NL-13-122

**SUBJECT:** Reply to Request for Additional Information Regarding  
the License Renewal Application  
Indian Point Nuclear Generating Unit Nos. 2 & 3  
Docket Nos. 50-247 and 50-286  
License Nos. DPR-26 and DPR-64

REQUEST FOR ADDITIONAL INFORMATION, SET 2013-04  
RELATED TO INDIAN POINT NUCLEAR GENERATING UNIT NOS. 2 AND 3  
LICENSE RENEWAL APPLICATION

REACTOR VESSEL INTERNALS PROGRAM AND INSPECTION PLAN

**Figure 1 Lower Radial Support System Engagement**

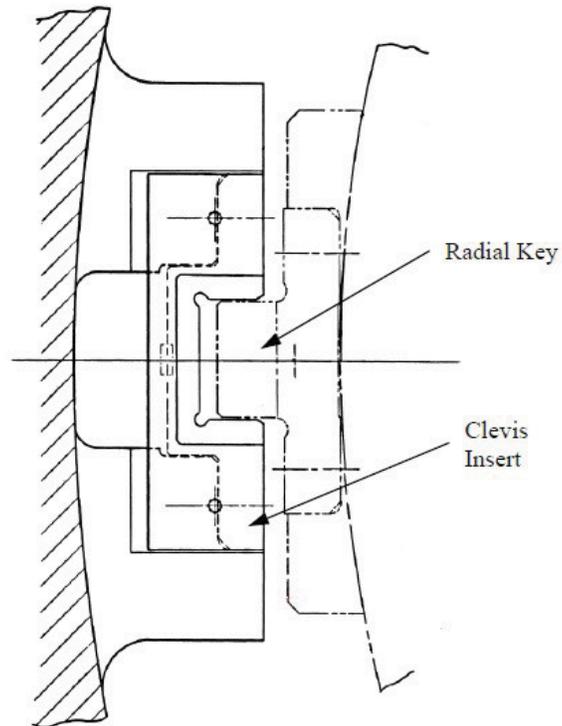
Appendix A to MRP-227-A indicates that failures of Alloy X-750 clevis insert bolts were reported by one Westinghouse-designed plant in 2010. A recent metallurgical analysis of bolts removed from this plant confirmed that the bolts cracked due to primary water stress corrosion cracking (PWSCC). Appendix A to MRP-227-A indicates that most of the failures of Alloy X-750 material have occurred in material with heat treatment condition AH1, while Alloy X-750 given the high temperature heat treatment (HTH) has proved more resistant to PWSCC.

The only aging mechanism requiring management by MRP-227-A for the clevis insert bolts is wear. The clevis insert bolts are categorized as an "Existing Programs" component under MRP-227-A, with the ASME Code, Section XI Inservice Inspection program credited for managing aging due to wear only. The ASME Code, Section XI specifies a VT-3 visual inspection for the clevis insert bolts which may not be adequate to detect cracking before it results in bolt failure.

The staff requests that Entergy modify the MRP-227-A inspection requirement for the clevis insert bolts as necessary to manage the effects of PWSCC for the IP2 and IP3 bolts. If the inspection requirement is not modified, the staff requests that Entergy provide a technical justification for the adequacy of the existing inspection requirement to manage PWSCC.

Entergy provides the following technical justification for the adequacy of the existing inspection requirement to manage the effects of PWSCC.

The main function of the lower radial support system (LRSS) is to prevent tangential or rotational motion of the lower internals assembly while permitting axial displacement and differential radial expansion. Indian Point Units 2 and 3 have six radial supports spaced at 60 degree intervals around the circumference of the vessel (see Reference [5], Figure 1). Because of the small tangential clearance between the radial keys and the clevis insert, the keys are potentially subjected to flow-induced vibration loads and wear at the key-to-keyway (clevis) interface. These supports are designed to prevent excessive tangential displacement of the lower internals during seismic and loss of coolant accident (LOCA) conditions. The supports also limit displacements and misalignments in order to avoid overstressing the core barrel and to ensure that the control rods can be freely inserted. Therefore, providing the clevis inserts remain in place, the design function of the LRSS will be maintained during seismic and LOCA conditions.

Crack detection prior to bolt failure is not required due to inherent design redundancy. The ability of the LRSS to perform its intended design function under seismic and LOCA condition loadings is unrelated to the integrity of the cap screws and pins that are used to hold the clevis insert in place. The cap screws and the dowel pins hold the clevis inserts in place so as to minimize long term vibration and wear of the mating parts.

Should cap screws fail during operation, it could result in potential increased wear of mating surfaces. Any increased wear, which would occur over several operating cycles, will not impact the function of the reactor internals components. This is based on operating experience with

damaged bolts and one dowel pin as described in the InfoGram [5] which showed no discernible change in the clevis insert wear surfaces after operation for two additional cycles.

Complete disengagement of one of the clevis inserts is highly unlikely based on the available gaps with surrounding components (see Figure 1). Even if it were postulated that one of the clevis inserts becomes non-functional, the other lower radial supports are capable of resisting all of the internal and external asymmetric loads. Wear or some degradation of a key might occur, but the key would still be expected to maintain functionality. Taken as a whole, the core barrel and LRSS system are expected to maintain their design function with degraded clevis insert bolts. Based on the evaluations performed to date, there are no safety or operability concerns with clevis insert bolt failure.
